Addendum 1
Solicitation 20-99344
Shoreline Rehabilitation near Water Treatment Plant

PROJECT CONSTRUCTION ACCESS
DULUTH SHORELINE REHABILITATION - TREATMENT PLANT

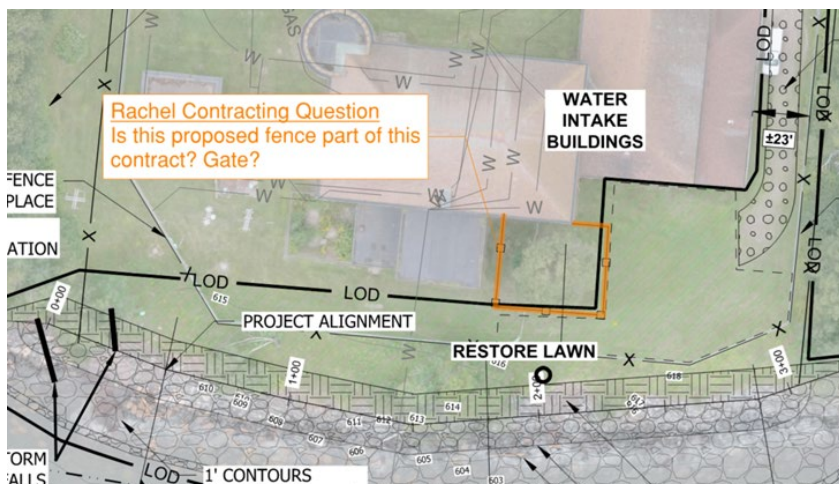
7. Is the proposed fence located south of the facility part of this contract? Would there be a gate with this fence? See area of interest highlighted in orange below.
 - a. The fence and the curb it sits on are existing. Contractors determine how much they need to remove to perform the work and are responsible for repairing it to

original condition or replacing it in kind. Please see the attached temporary fencing drawing as a suggested solution. Exact location to be determined at the beginning of work.

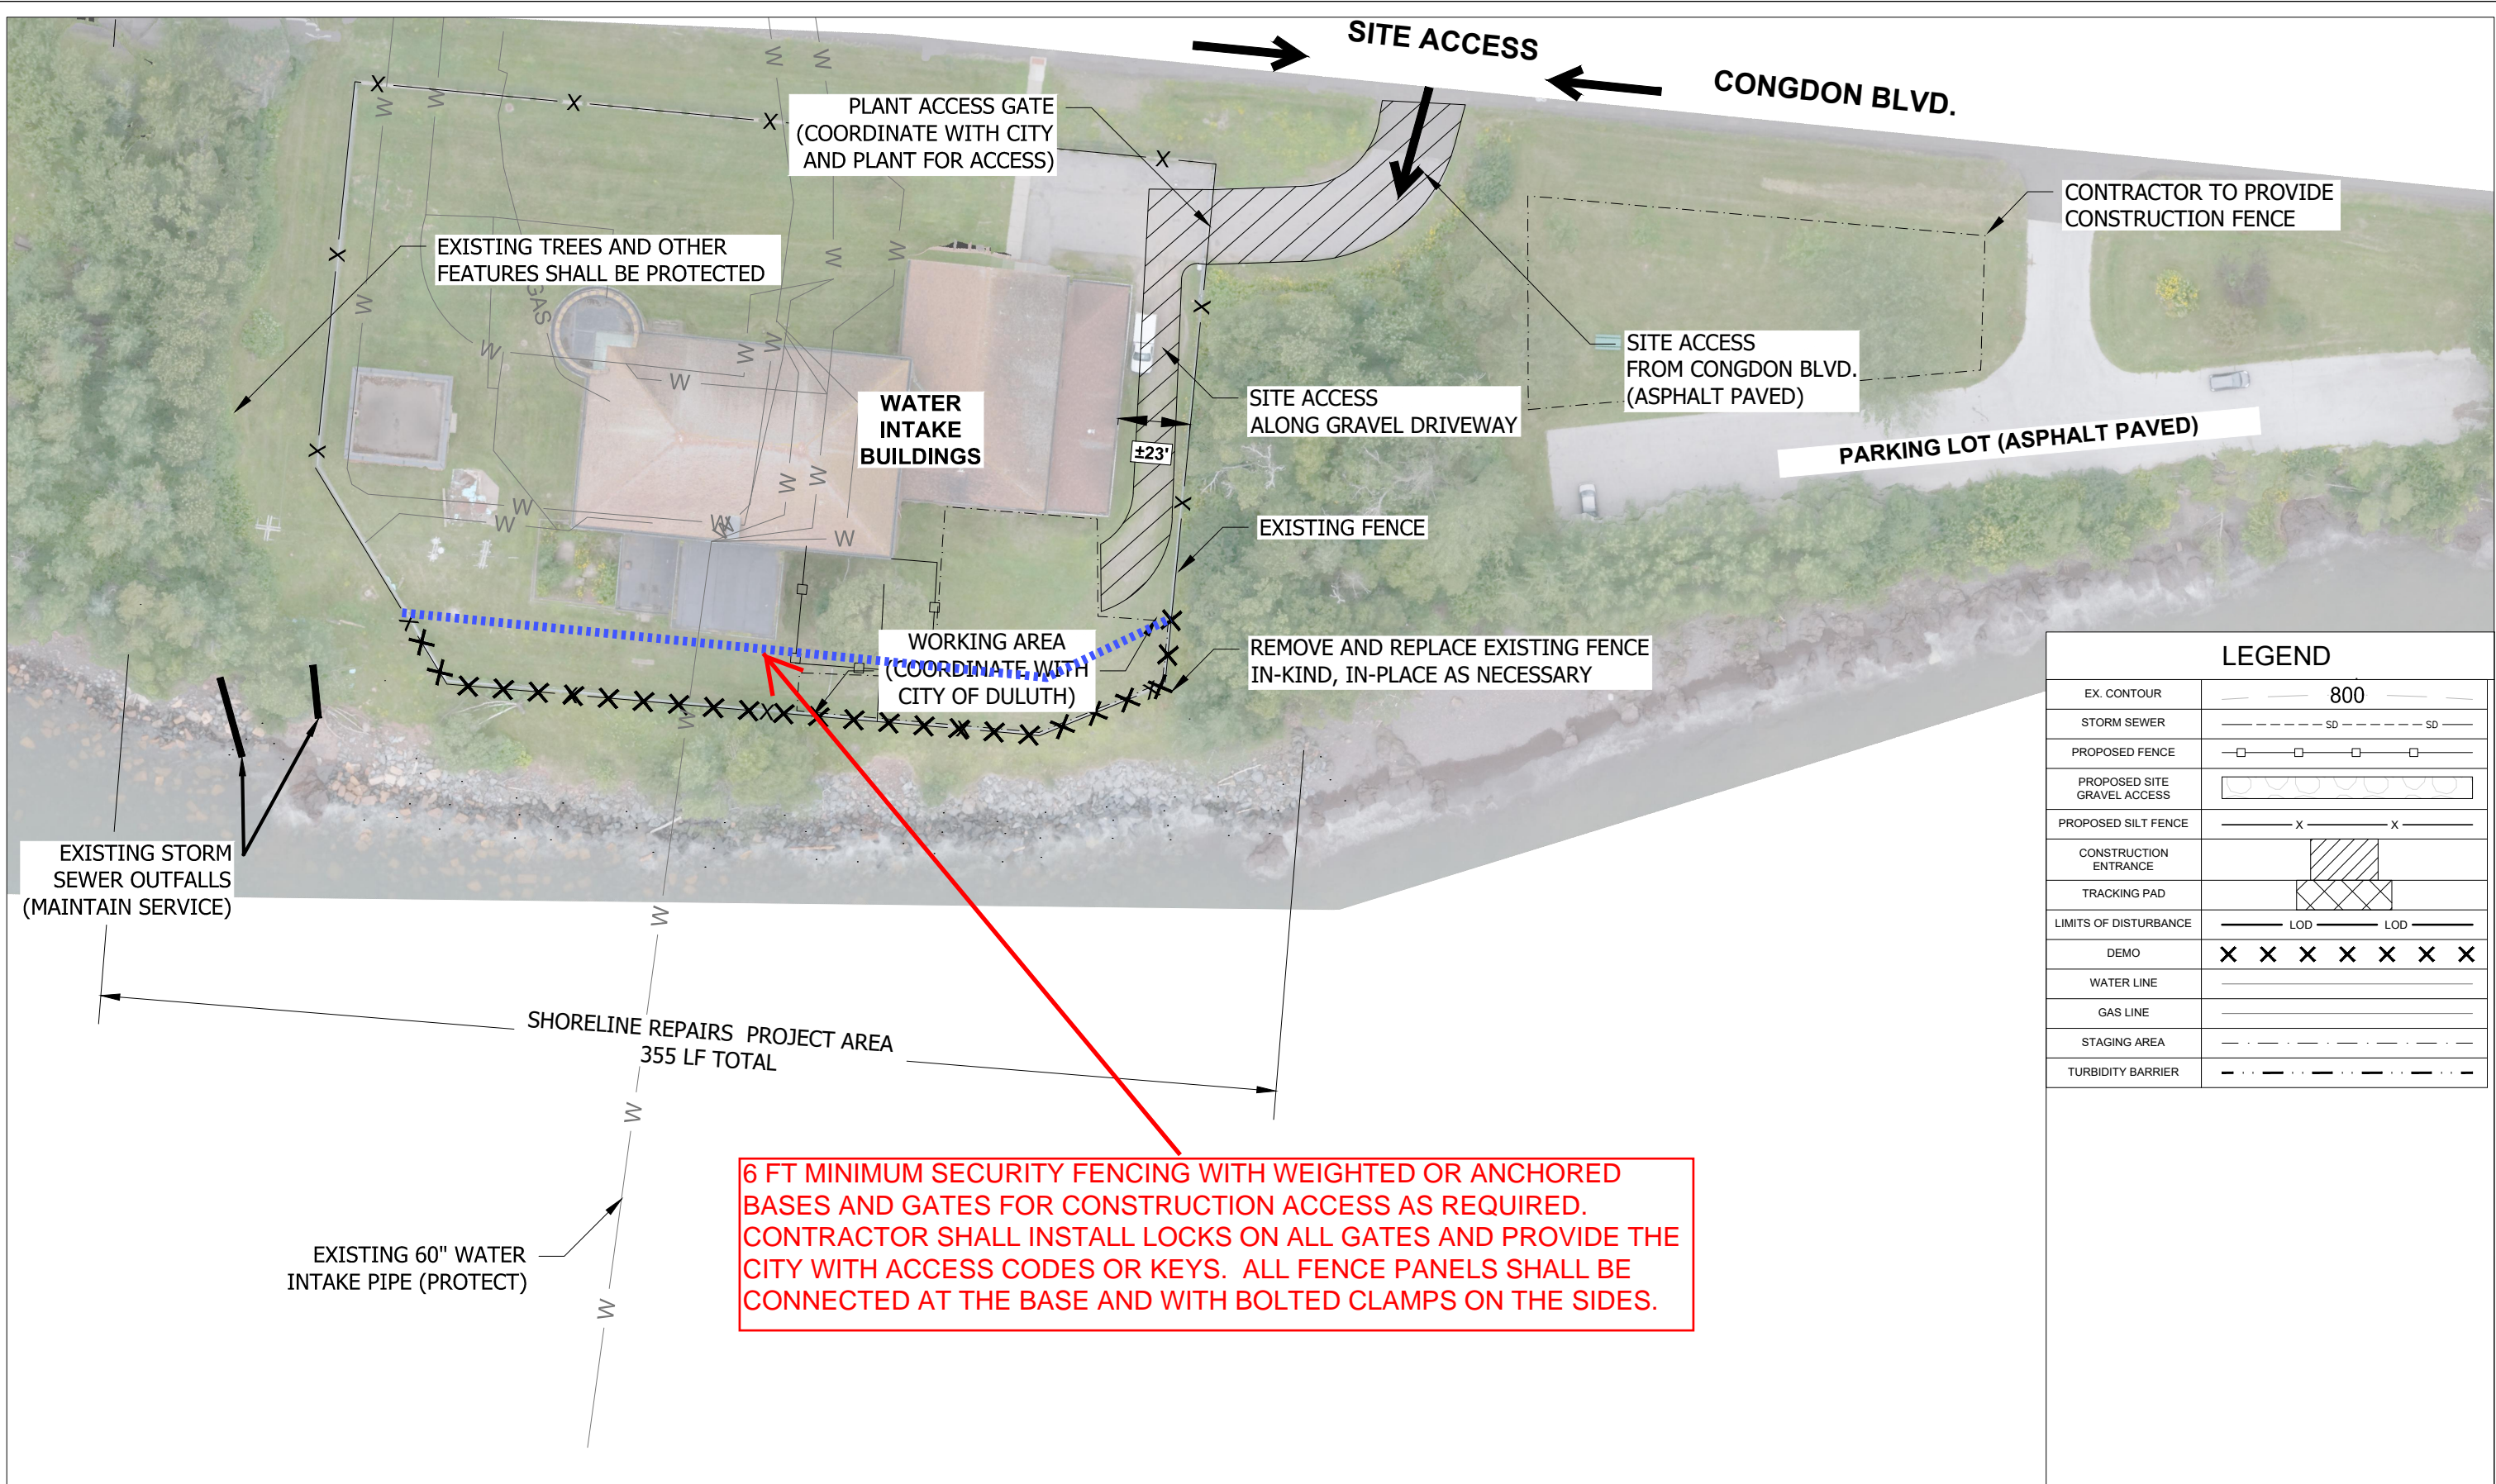
12. Armor stone and toe stone interlock will be critical throughout this project. Each rock must be carefully placed to ensure excellent interlock.
13. Rebar anchors at 2 ft on center shall be installed to hold toe stone on exposed bedrock (see attached detail). Exposed bedrock exists on north and south ends of project. The bid form has been updated to include the quantities below.

- a. Total quantity estimated (above water line) = 60
 - b. Total quantity estimate (up to 2 ft below water line) = 10
14. Does the silt fencing have to return from the shoreline towards the road on the southwest side of the project?

#11 BAR W/ STD HOOK INSTALLED PARALLEL TO REVETMENT, EMBEDDED INTO BEDROCK @ 2'-0" OC IN 1.75" DIA HOLE W/ HIGH STRENGTH NON-SHRINK GROUT. SPACING AS REQUIRED TO FULLY STABILIZE ARMOR STONE REVETMENT TO FULLEST EXTENT POSSIBLE
